**Ward 3 Recreation Various Projects
Addenda #3**

The following shall modify the Bid Documents:

Ward 3 Recreation
Various Projects at Power Center
Sports Complex

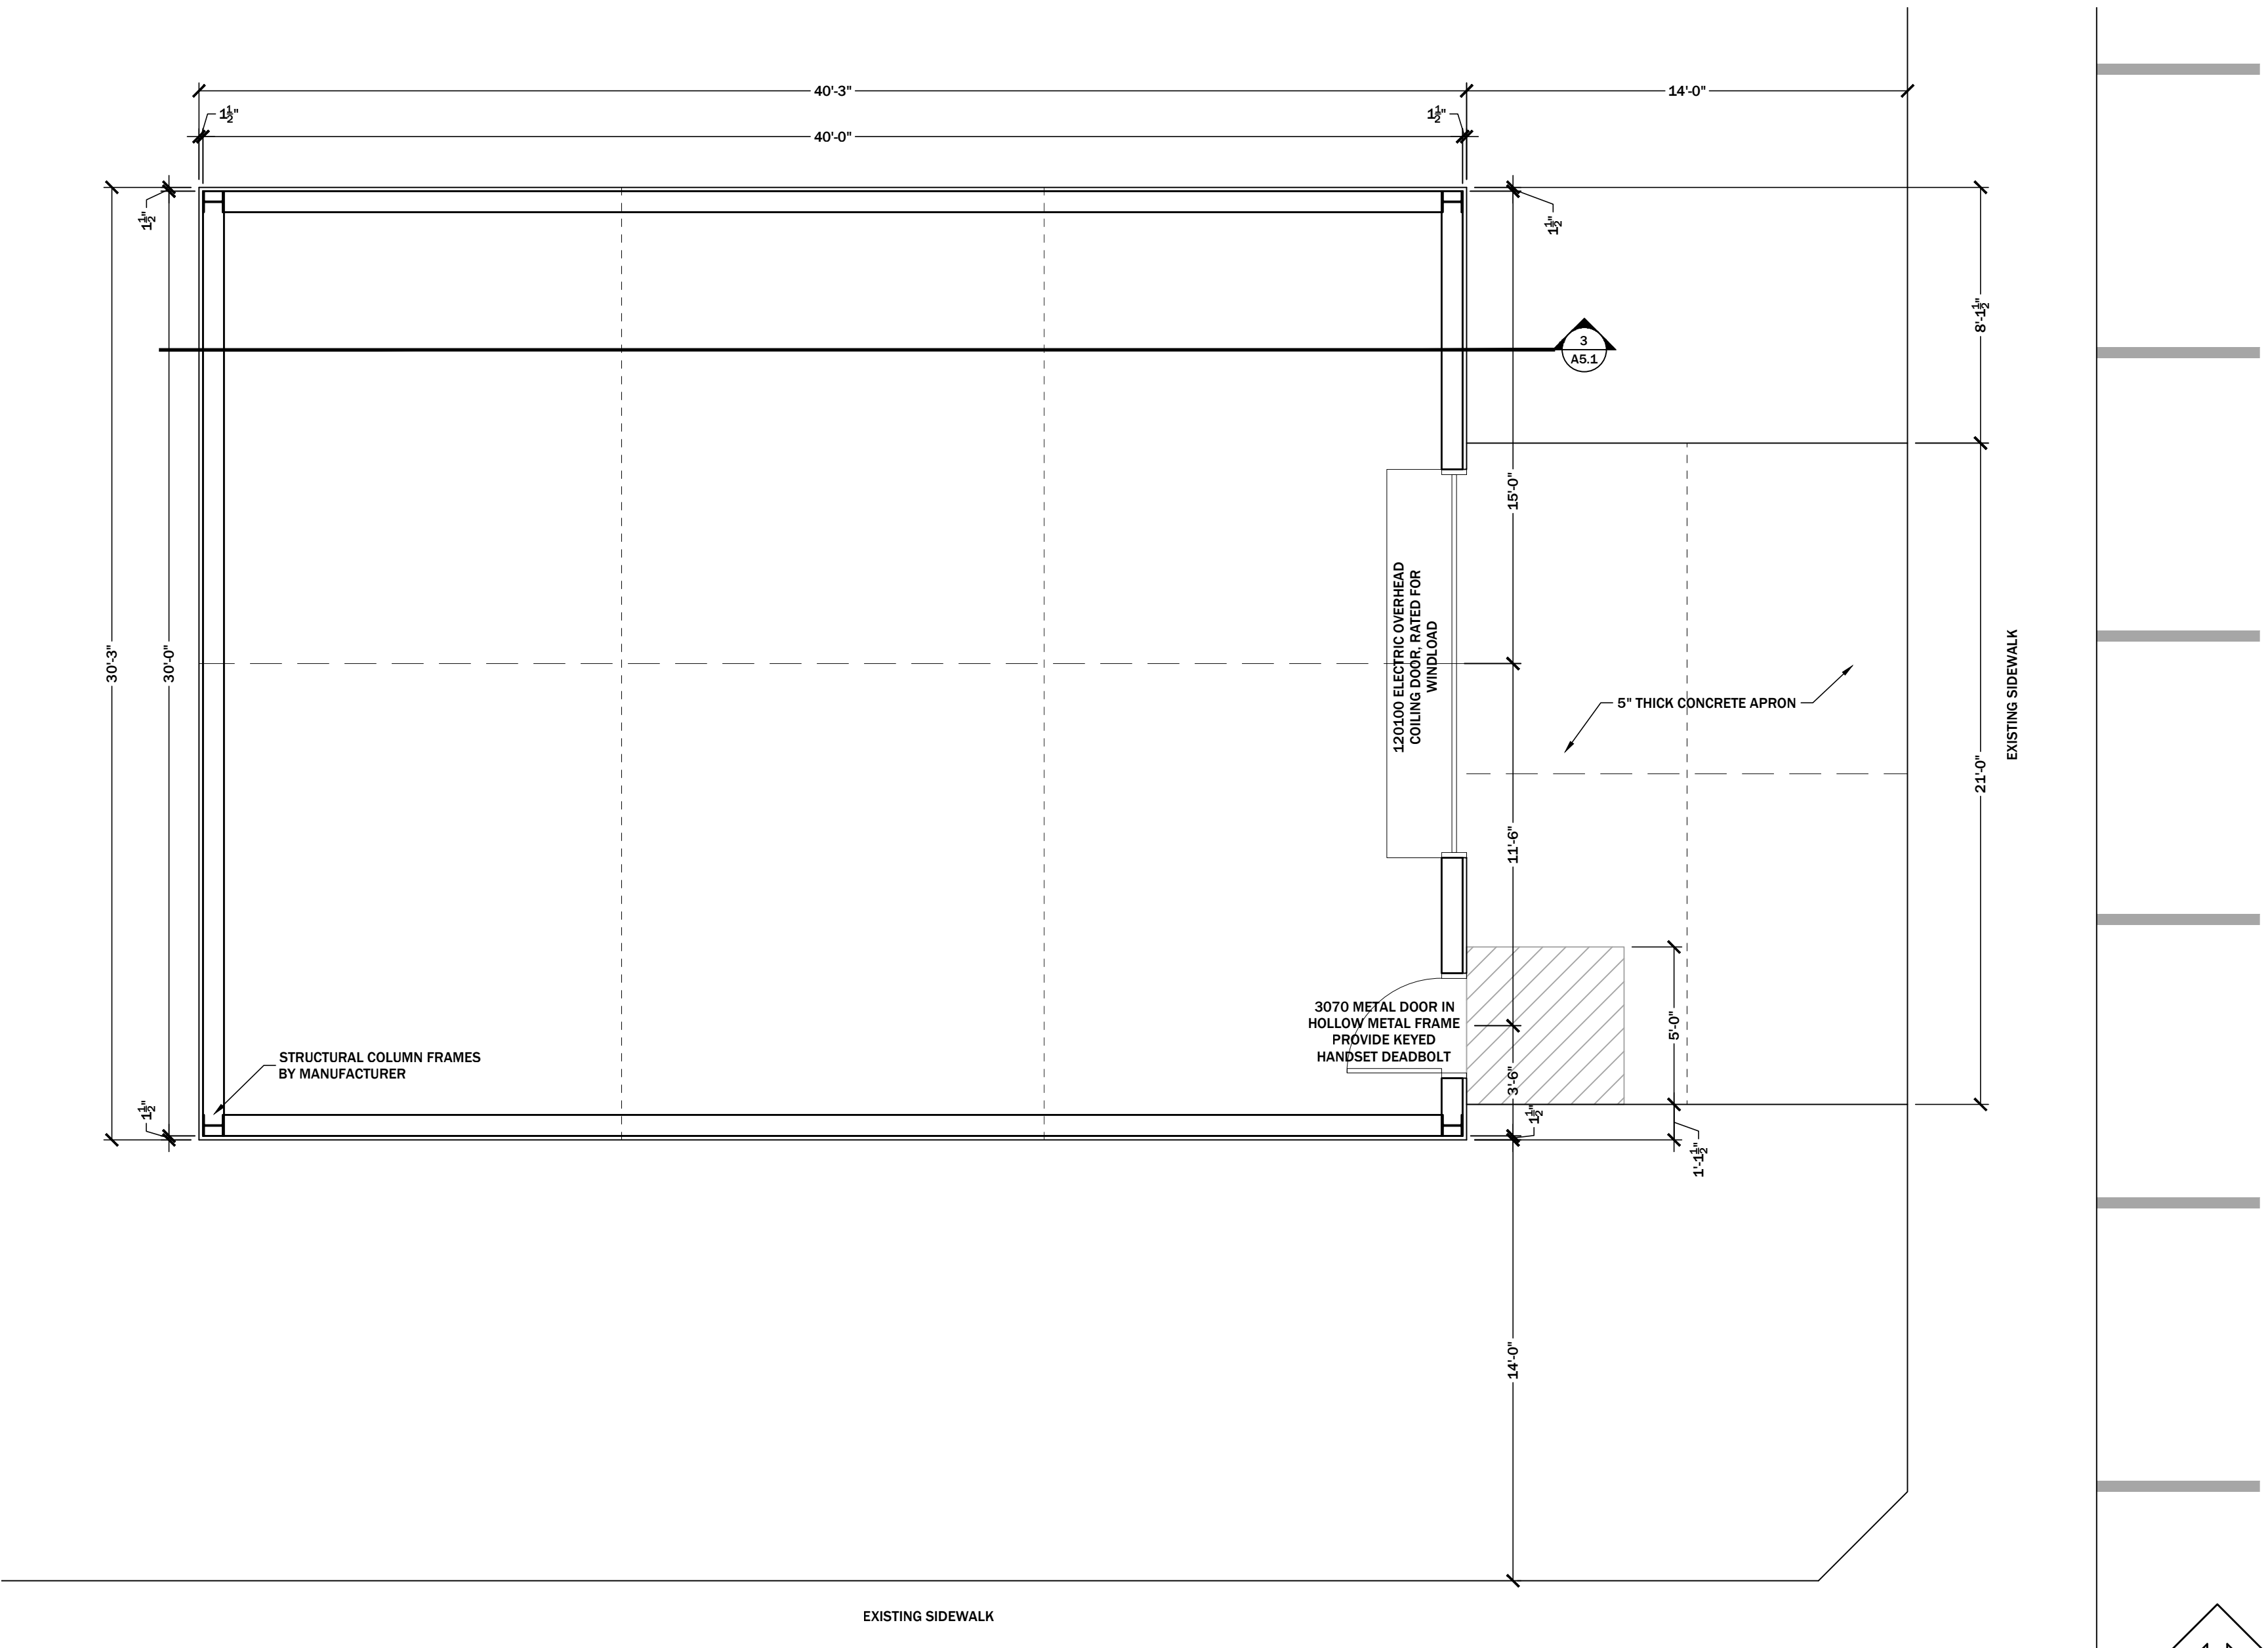
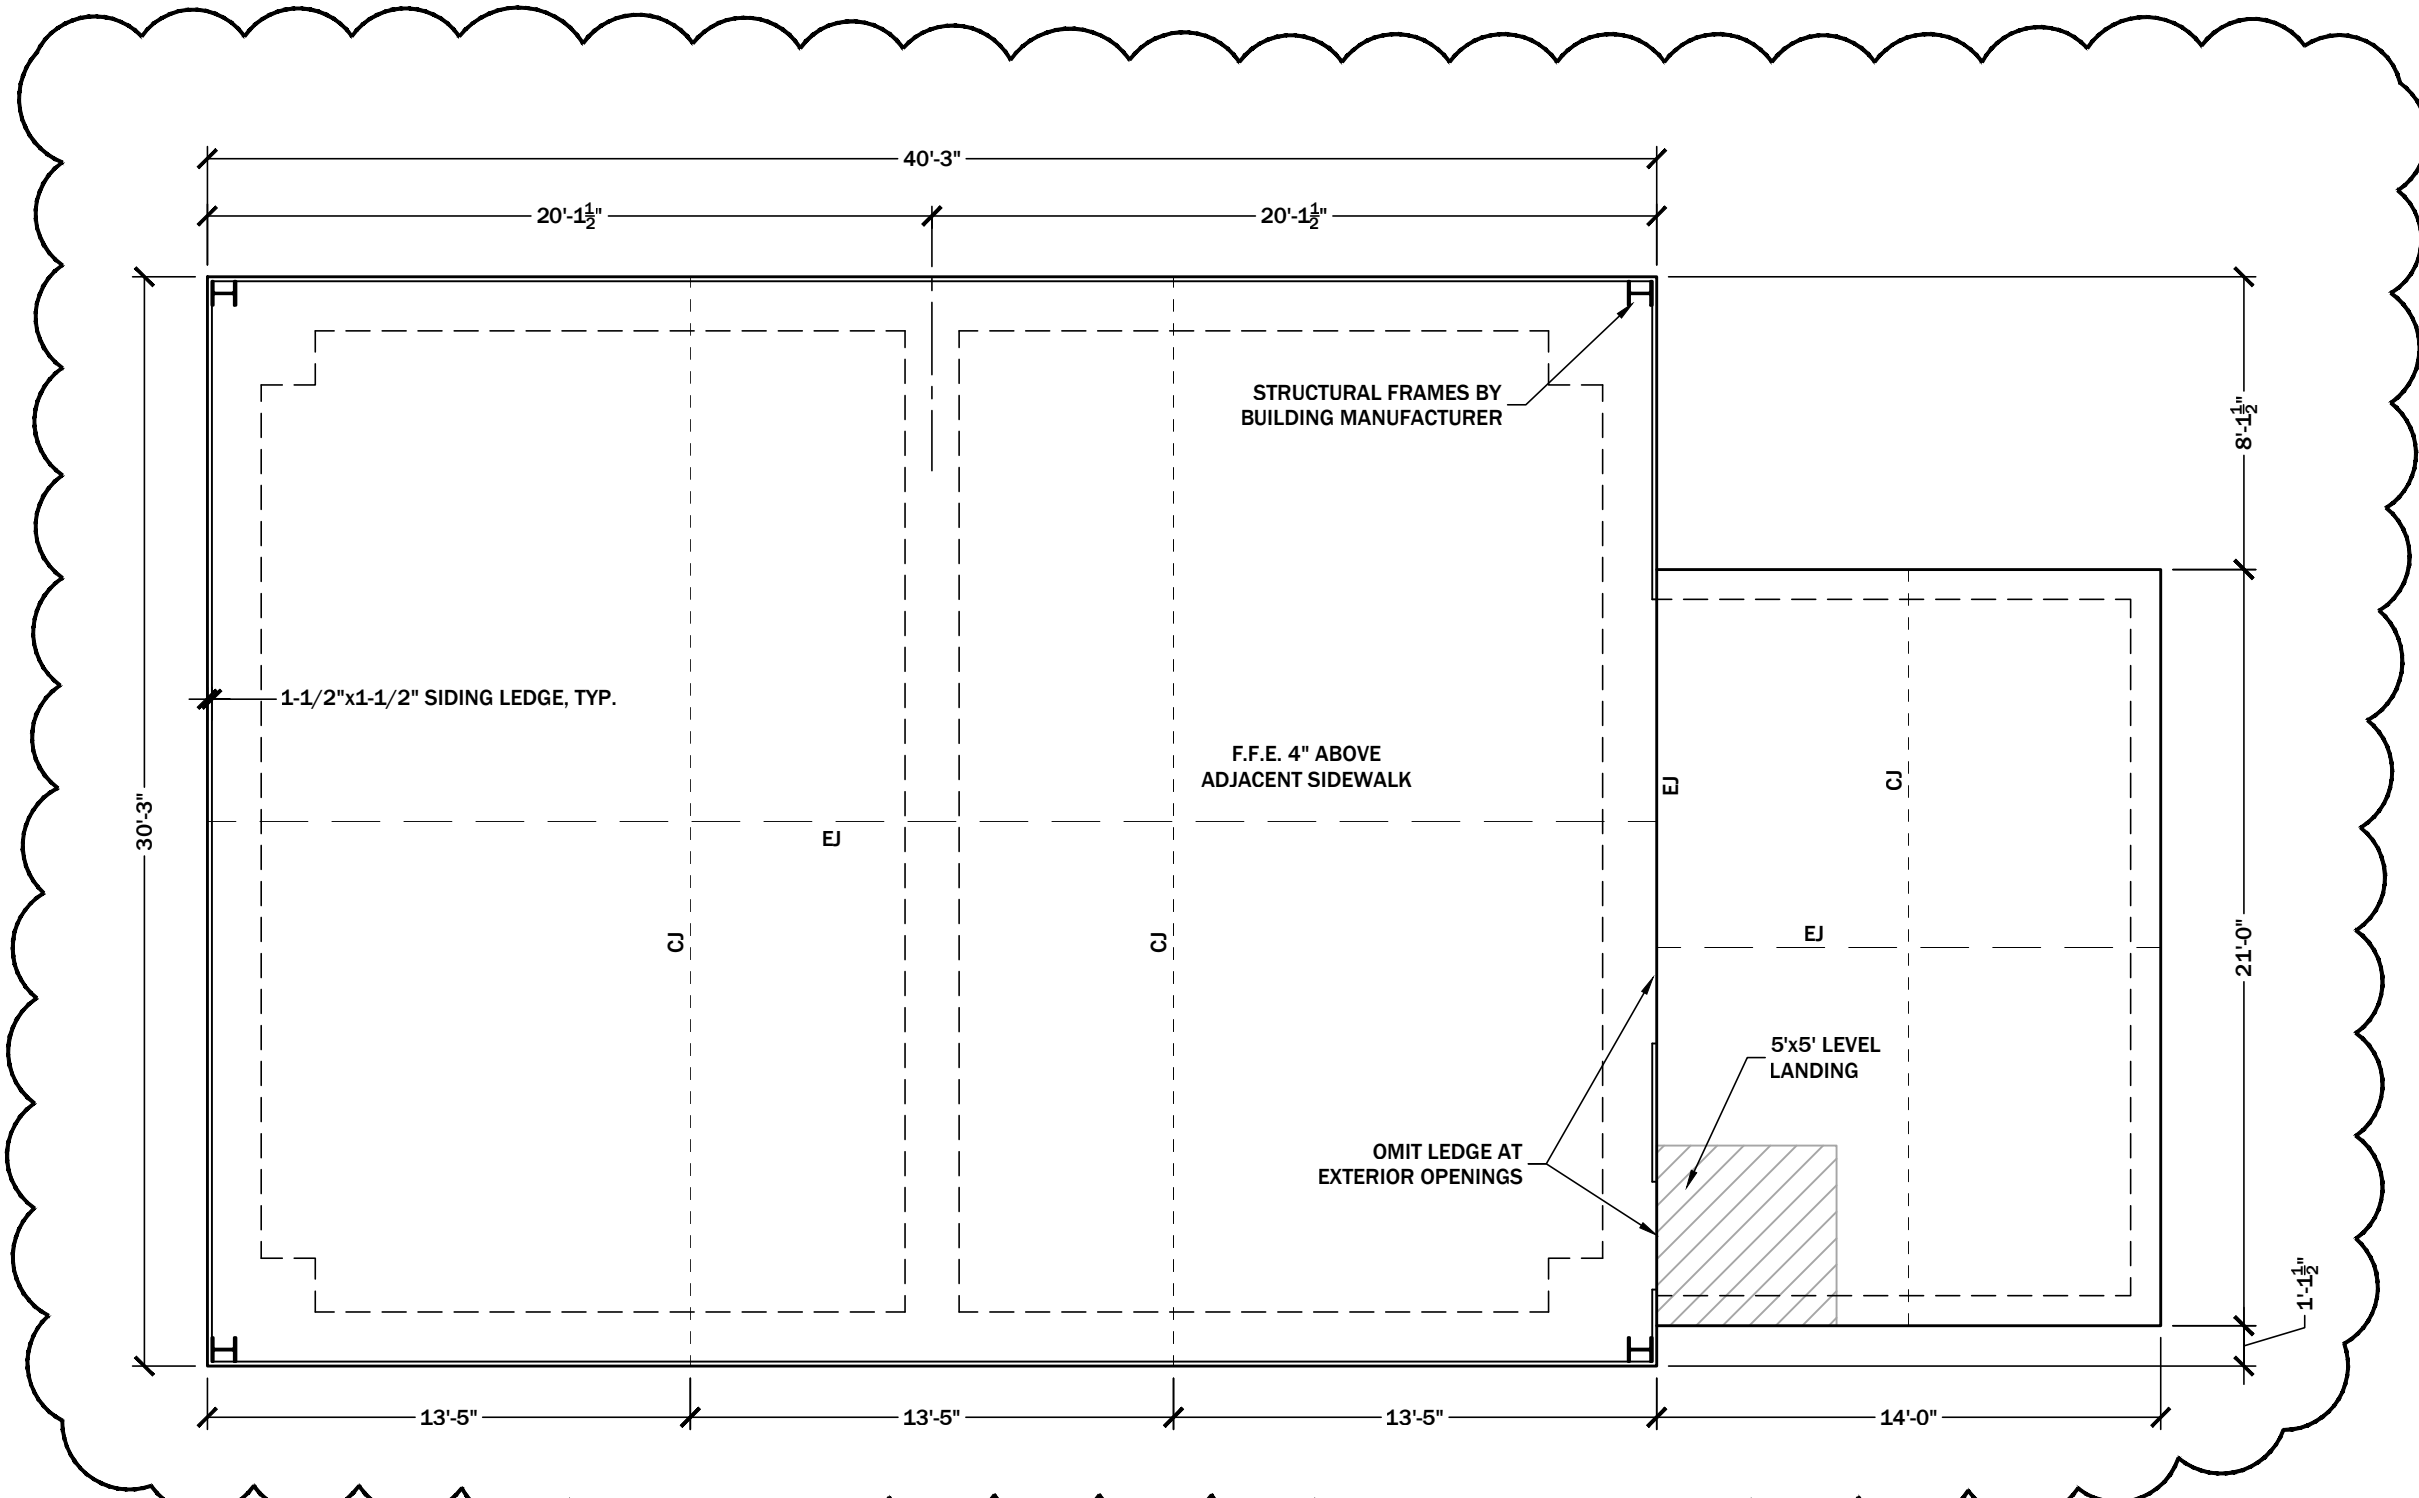
6. See attached Storage Building plan with added paving details.
7. The specified helical piles at the new Canopy may be substituted with concrete drilled shafts as indicated on the attached.
